# Final Determination of Compliance

# Marsh Landing Generating Station

Bay Area Air Quality Management District
Application 18404

June 2010

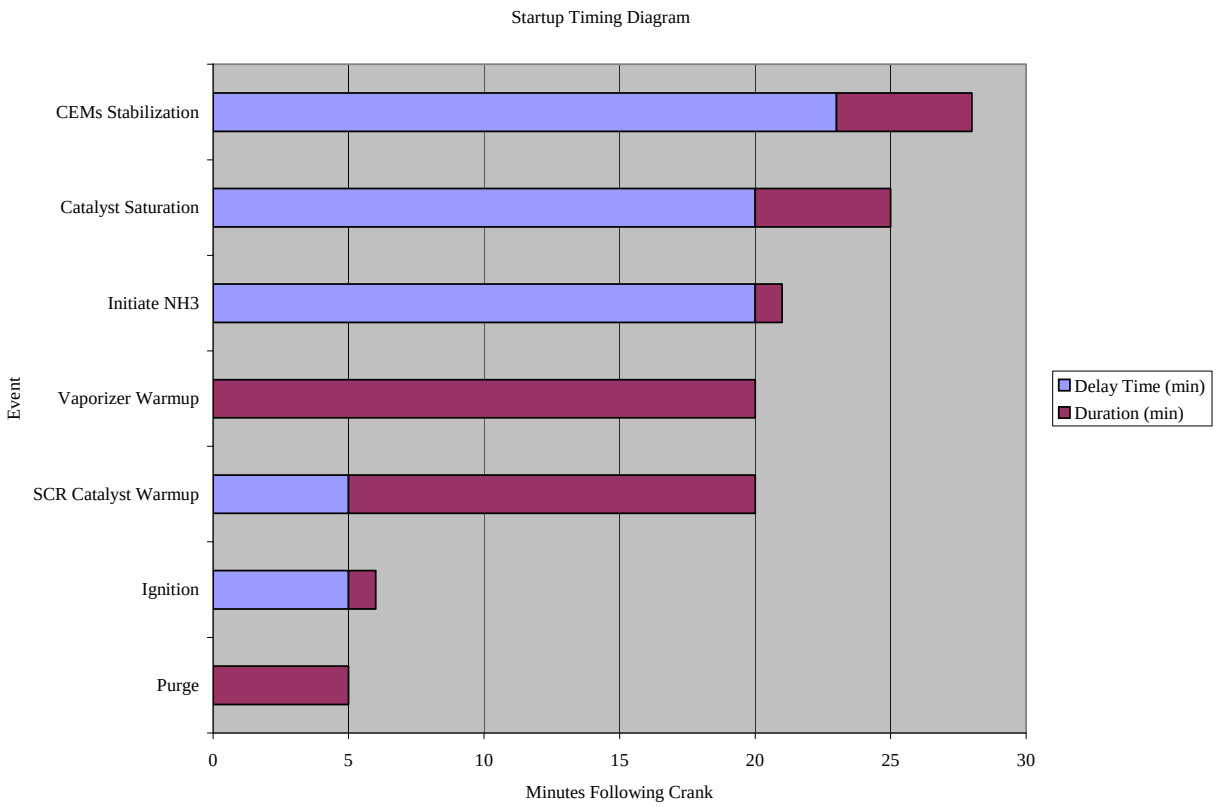
The SCR vendor estimates that it would take approximately 23 minutes from ignition for this process to be completed. In order to develop a not-to-exceed BACT permit limit, and in order to accommodate inherent variability in individual startups, the District has assumed that under a worst-case scenario it could take as long as 28 minutes for the SCR system to begin effectively reducing $NO_x$ emissions. This additional 5 minutes provides a reasonable safety margin to ensure that the BACT limits will be achievable under all operating scenarios and that the facility will be able to comply with its permit limits even if a particular SCR warm-up takes a little longer than the vendor's 23-minute estimate. Once the SCR system is at temperature and fully functioning, it should only take a short time for $NO_x$ emissions levels to ramp down to the 2.5 ppm steady-state emissions limit, and so the applicant continues to believe that the gas turbines can complete startups within the 30-minute limit the District proposed in the PDOC, even with a 28-minute delay in the SCR system becoming effective.

Based on this new information on what startups would entail, it is clear that the 18.6 lb startup $NO_x$ limit proposed in the PDOC would not be feasible and is not BACT. Instead, BACT needs to be based on the 14 pounds of emissions from the turbine during the 11 minutes it will take the turbine to start up and reach its uncontrolled $NO_x$ emissions rate of 9 ppm (*i.e.*, the steady-state emissions rate for the turbine only without the SCR system); then an additional 15 minutes of operation at 9 ppm with no reduction from the SCR system during the time needed for the SCR system to start working; and then rapidly declining $NO_x$ emissions during the last 3 minutes of the 30-minute startup period. This calculation is set forth in the spreadsheet on the next page, which is based on emissions information submitted by the project applicant and reviewed by the District. It assumes 14 pounds of $NO_x$ emitted during the 11-minute turbine startup, then 15 minutes of operation without the SCR system with emissions of 1.25 pounds per minute (based
